AFFIDAVIT OF James M. Coger

- 4) I have been the RRD District Geologist for the Gelman Sciences, Inc. site, located at 600 South Wagner Road, Ann Arbor, Michigan, for approximately four years. As the District Geologist, I have reviewed and commented on the following Pall Life Sciences, Inc. (PLS) submittals that are relevant to this affidavit: Work Plan for Test Boring/Well Installation and Aquifer Testing in the Wagner Road Area, dated August 1,

CROSS SECTION A-A'

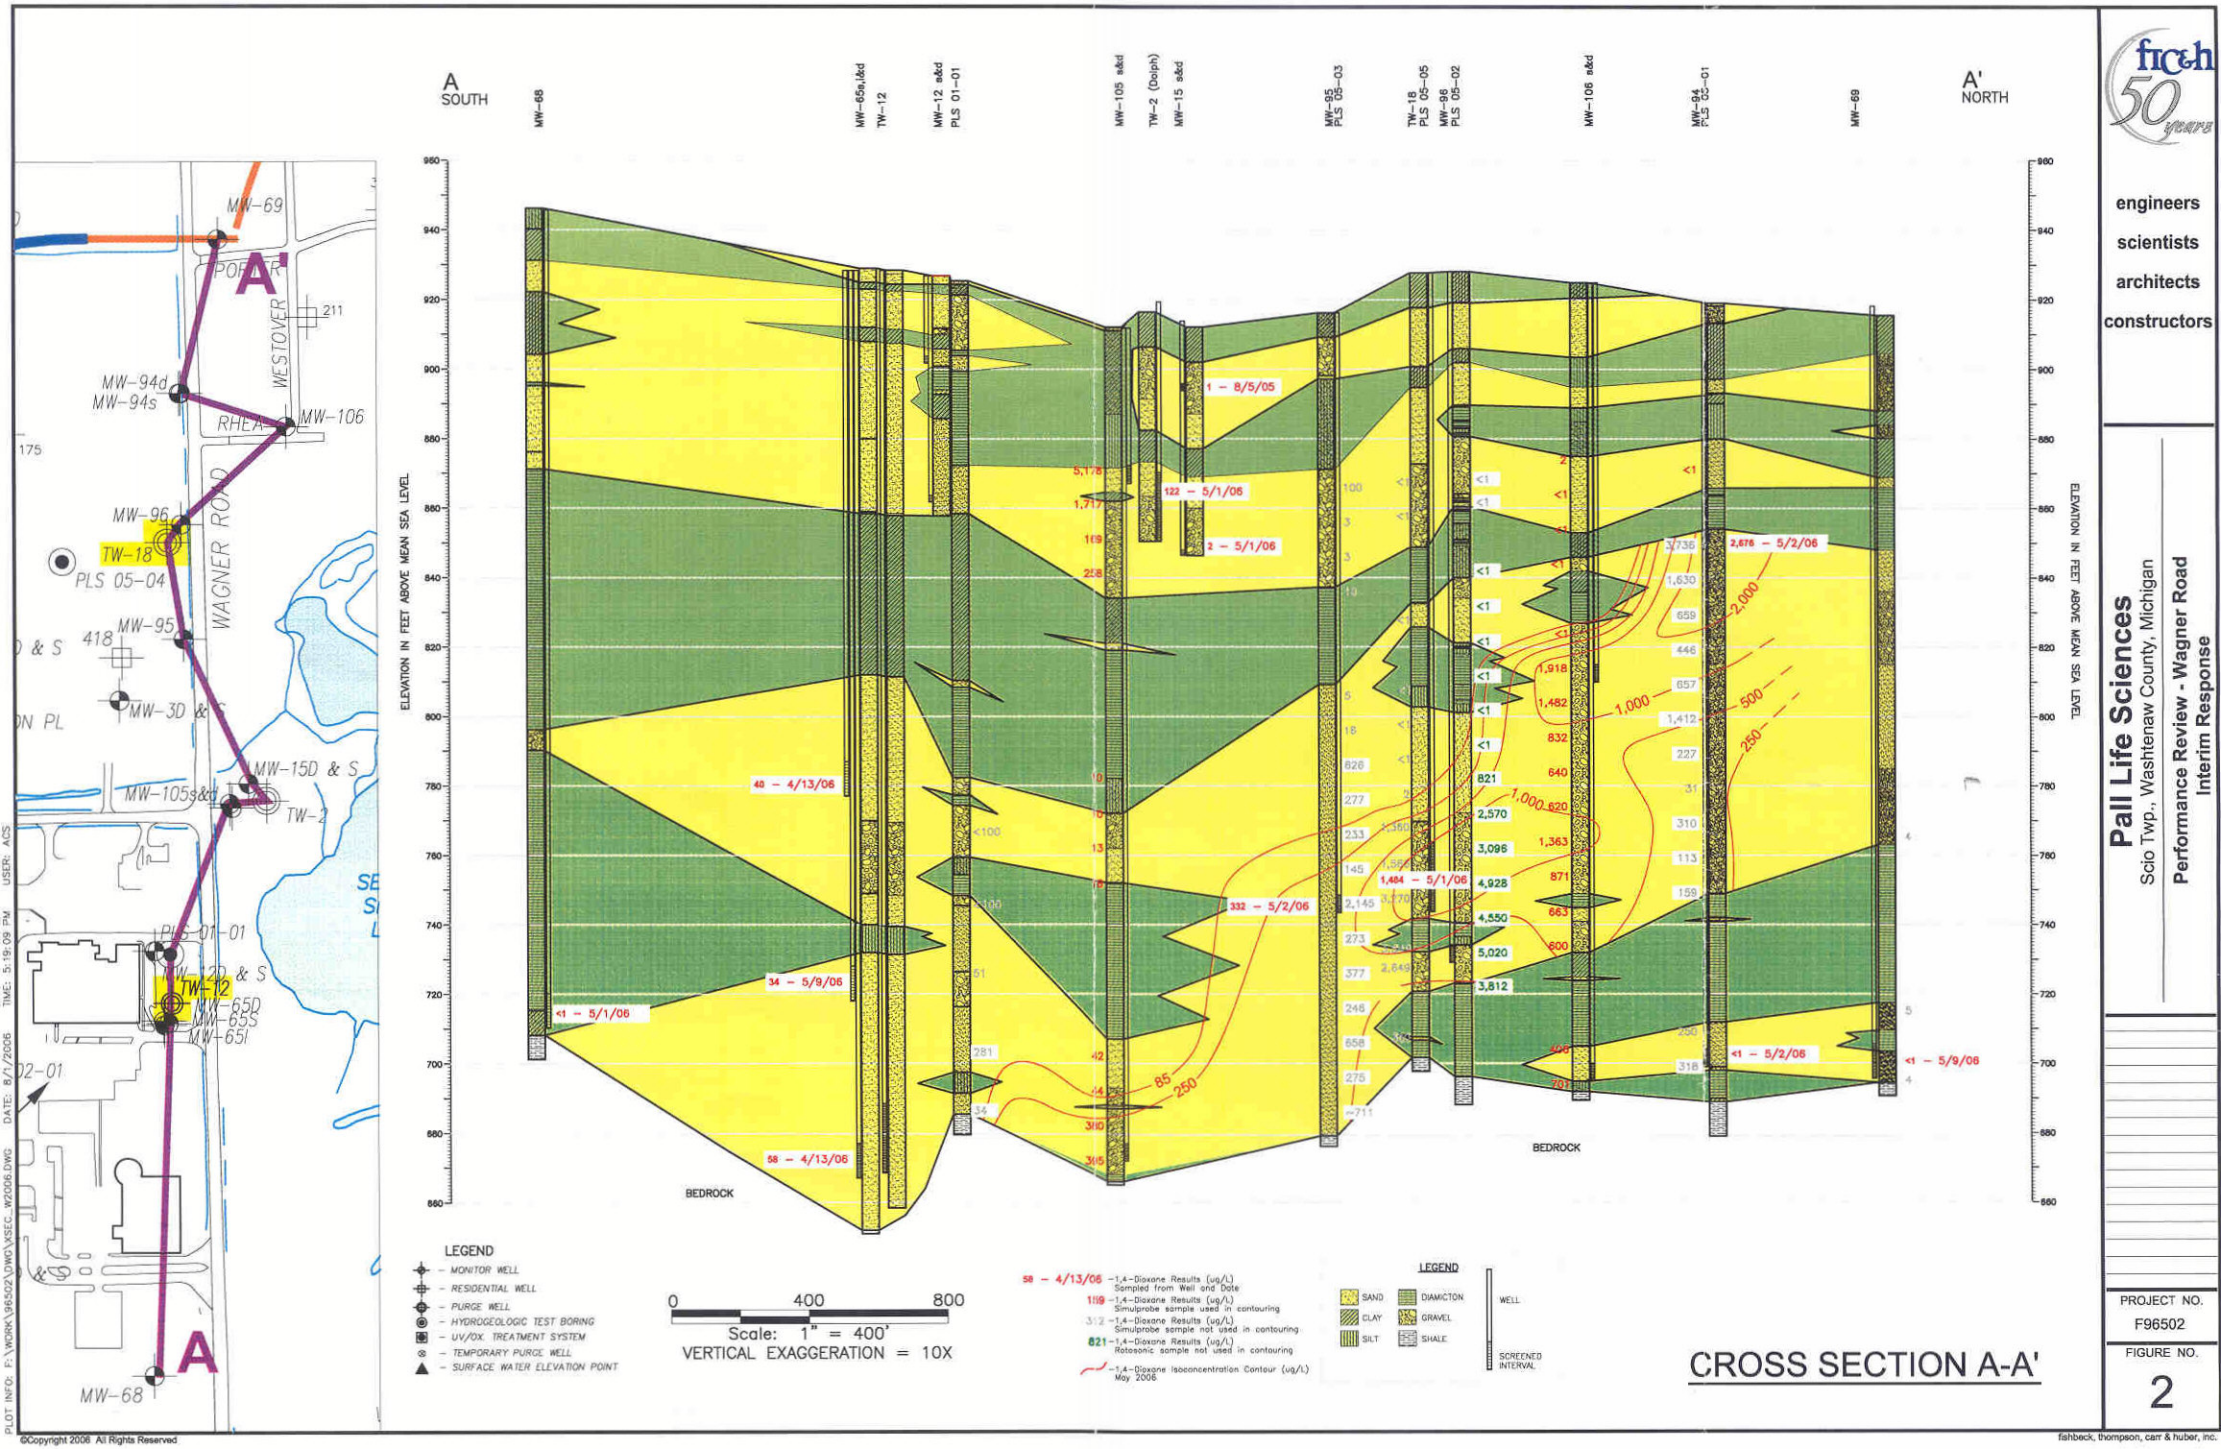
6) Soil boring logs provided by PLS for monitor wells MW-95, TW-18, MW-96, and MW-94s and d, depict a thick conductive aquifer extending from approximately 80 feet below ground surface, to the bedrock and/or to elevations just above the bedrock, for the general area of Wagner Road between MW-105d and MW-94s and d,. (see attachment 1, PLS Performance Review- Wagner Road Interim Response Cross Section A-A', Figure 2). Approximately 60 – 120 feet of contamination, exceeding 85 ppb, was encountered vertically throughout the aquifer during installation of MW-95, TW-18, MW-96, and MW-94s and d. There is no aquitard or confining unit that hydraulically separates the intermediate (Unit D2) contamination from deeper (Unit E) contamination as it migrates eastward under Wagner Road. The aquifers, designated

by PLS as Unit D2 and Unit E, are a single thick saturated interval between monitoring wells MW-105d and MW-94s.

FIGURE NO.
3

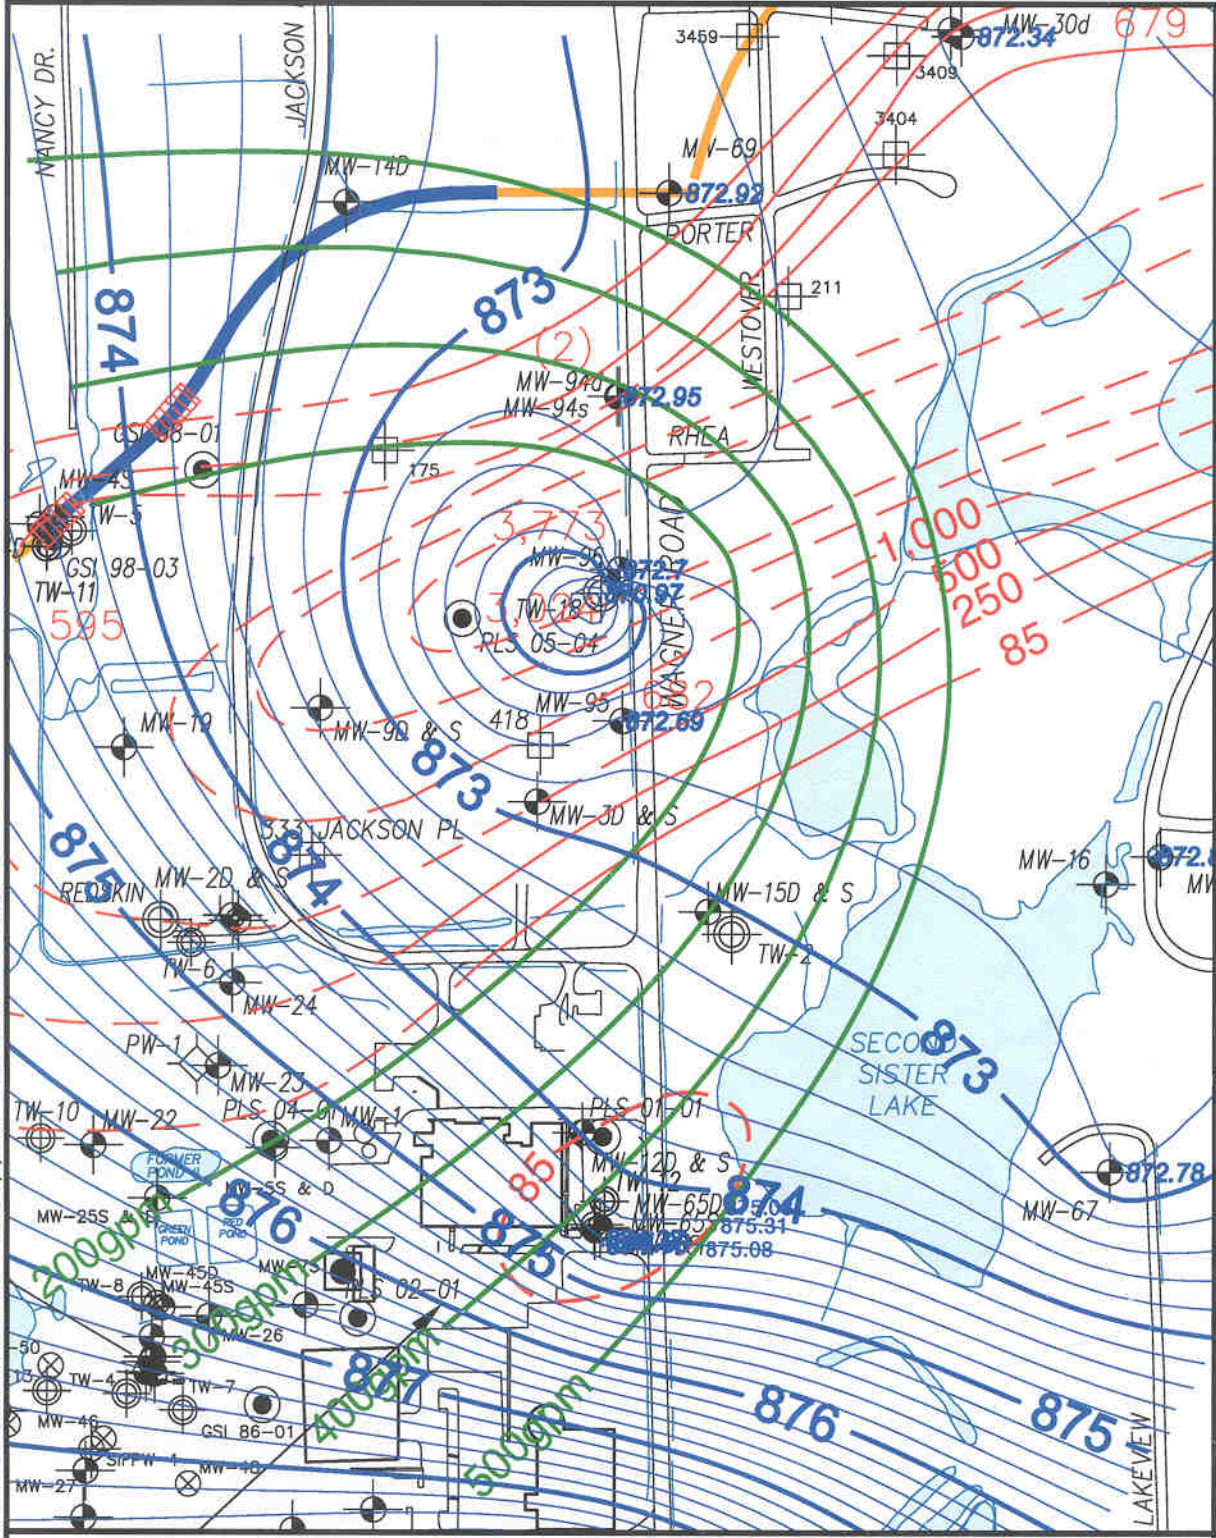
8) Purge well TW-18 was installed for the purpose of intercepting and hydraulically containing 1,4-dioxane contamination in the deep Unit E aquifer. Attachment 2, is Figure 3 from PLS's TW-18 Capture Zone Analysis, August 2005 Wagner Road Work Plan. Figure 3 depicts groundwater flow direction, 1,4-dioxane contaminant distribution, and the modeled capture zones for purge well TW-18 extracting groundwater under various purge rates. The capture zone contours for TW-18 are based on a model that predicts hydraulic capture in an aquifer with homogeneous characteristics, under groundwater extraction rates of 200, 300, 400, and 500 gallons per minutes (gpm).

9) It is my opinion that due to the non-uniform nature and thickness of the aquifer matrix in the Wagner Road area, the actual hydraulic capture of TW-18 is less than the modeled hydraulic capture depicted by Figure 3. PLS has not provided a subsequent analysis of hydraulic head and/or hydraulic gradient data that demonstrates the

modeled Figure 3 capture zone contours are representative of actual hydraulic conditions.

14) The Figure 3 capture zone contouring and monitoring results for monitor well MW-94s also reflects that TW-18 is not preventing the migration of groundwater contamination above 85 ppb of 1,4-dioxane eastward into the Unit E aquifer for the area of Wagner Road, north of Rhea Street. Concentrations of 1,4-dioxane have generally exceeded 2,000 ppb in MW-94s since it was installed in January 2005 (see attached trend chart for MW-94s). The absence of hydraulic containment is demonstrated by the lack of any downward trend in the MW-94s 1,4-dioxane monitoring results.

16) Hydraulic containment of 1,4-dioxane contamination exceeding 85 ppb at Wagner Road can be achieved with the installation of additional purge wells at variable elevations within the aquifer and at locations north and south of TW-18. The MDEQ requested that PLS consider installation of an extraction well at the MW-94s location, as a source control measure, in a letter dated March 7, 2006. Hydraulic containment of the

MW-105d

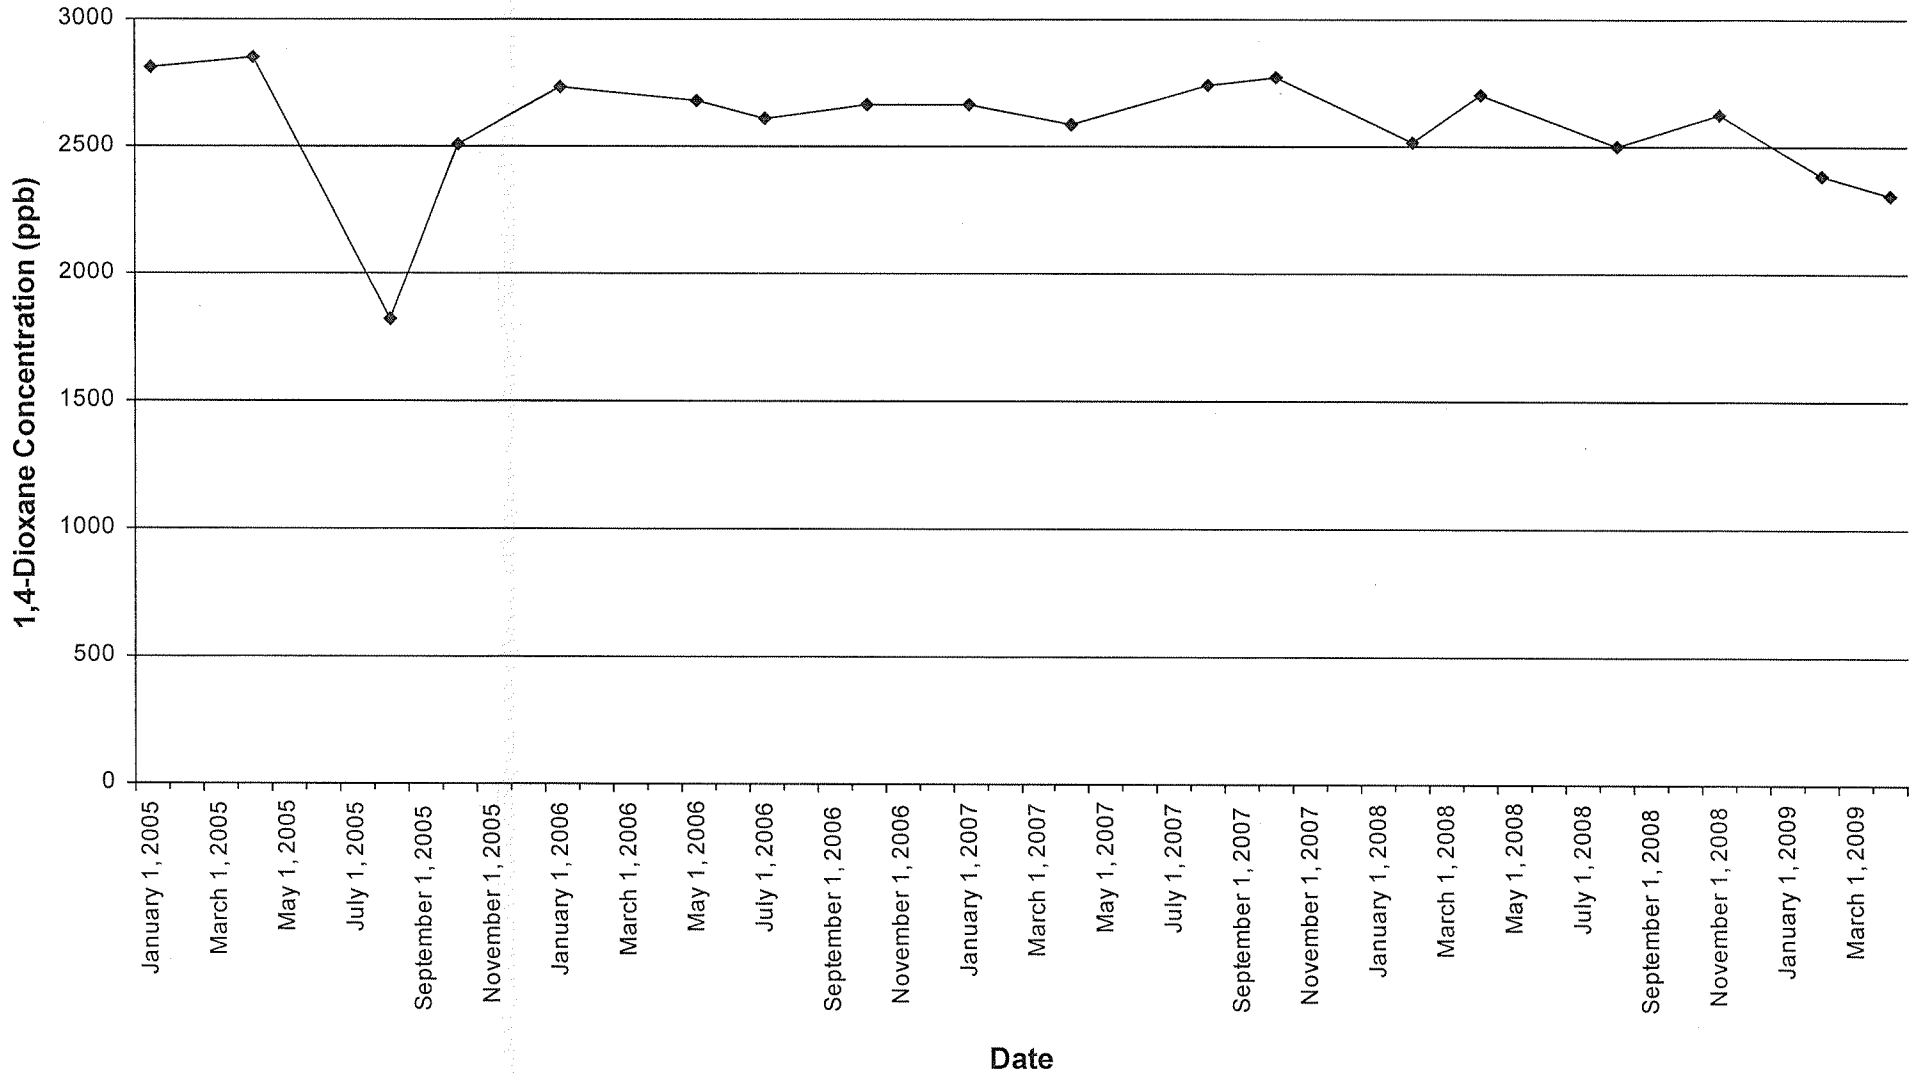
12) Groundwater sampling data from MW-105d reflects that 1,4-dioxane was first detected at 1,104 ppb in August 2006. Concentrations of 1,4-dioxane were detected at 654 ppb in April 2009 (see attached trend chart for MW-105d). Sampling results from MW-105d indicate that contamination extends farther south along Wagner Road than originally depicted by the 2005 Wagner Road Work Plan Figure 3, isoconcentration map. Groundwater contamination at MW-105d, above 85 ppb, is not being captured by TW-18, and continues to migrate eastward under Wagner Road.

15) As noted above, the aquifers designated by PLS as Unit E and D2 are a single undistinguishable saturated unit for the general area of Wagner Road between monitor wells MW-105d and MW-94s. Purge well TW-18, pumping at its current rate, is not influencing hydraulic control at MW-105d or at MW-94s as demonstrated by the monitoring data trend charts.
